# REGIONAL REVIEW FINDING

**Name of Proposal:** The Heights at Sandy Springs

**SUBJECT:** **Transportation Division Review of DRI # 2419**  
Project: The Heights at Sandy Springs  
County: Fulton  
Location: South-East Corner of Roswell Road and Franklin Road  
Analysis:  
Expedited ☐  
Non-Expedited ☒

DRI SITE PLAN (DRI #2419)  
THE HEIGHTS AT SANDY SPRINGS  
LAND LOT 94 - 17th DISTRICT  
CITY OF SANDY SPRINGS  
FULTON COUNTY, GEORGIA

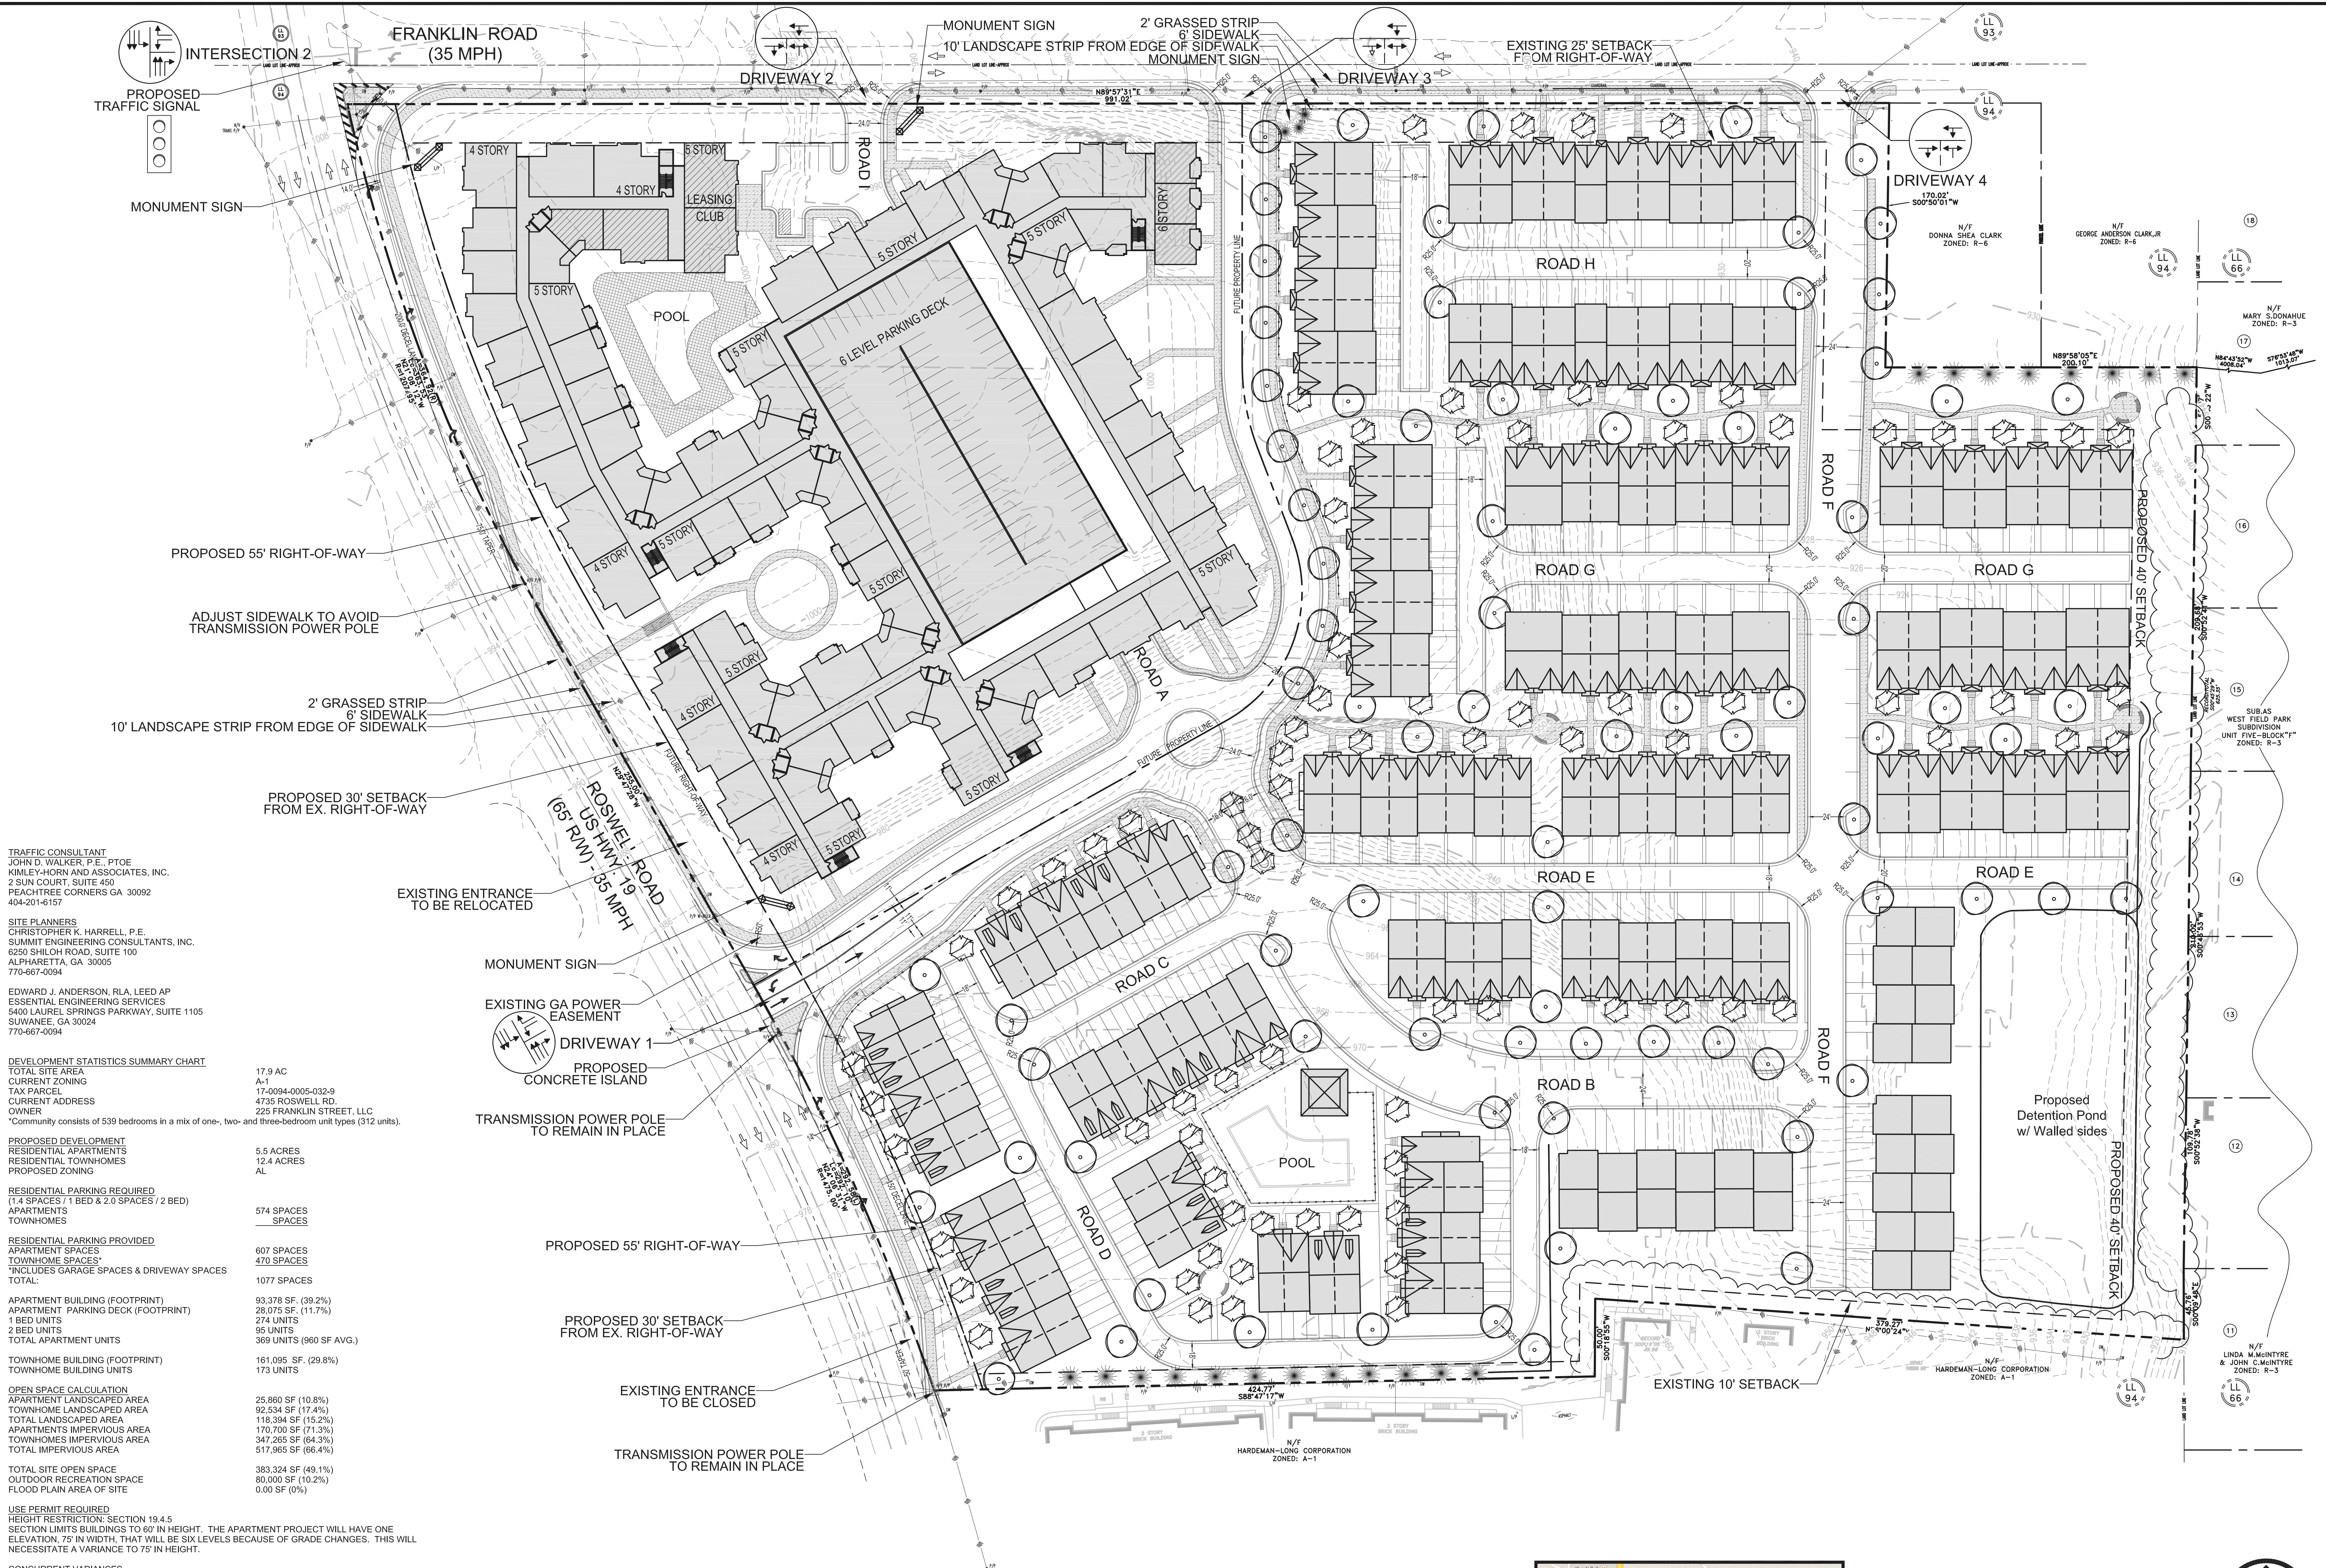
- The site plan shows a transmission power pole to be located in the triangular island for the northbound approach, which poses a concern for pedestrian movements (including persons with disabilities), and poses as a potential hazard for vehicles entering the site if control is lost by drivers due to inclement weather, etc.
- Study the potential to align main entrance on Roswell Road with the entrance to the townhome community across the street.
- A MARTA representative expressed a potential interest in moving the NB bus stop to the north in order to be closer to proposed HAWK signal and crosswalk which were proposed by the developer during the pre- pre-review DRI meeting.

- Internal site connectivity for pedestrians should include sidewalks and/or paths designed to accommodate safe movement for elderly persons and persons with disabilities between the different uses. The site plan shows paths in the townhome portion of the site, but no paths in the area around the pool and amenities.

- Ensure that public safety vehicles can access the townhome area and have enough room for movement within the central roundabout.

In terms of pedestrian and transit user safety, the site plan indicates that there are a lack of crosswalks between the sidewalk and the concrete pedestrian islands at the main entrance on Roswell Road. We suggest that the applicant provide crosswalks in this area to provide a better level of pedestrian safety. In addition, we request that the applicant provide an ADA compliant bus stop pad at the remaining stop as a part of the sidewalk design fronting Roswell Road. These suggestions are in line with pedestrian and transit user safety under the Georgia Department of Transportation's Complete Streets Program.
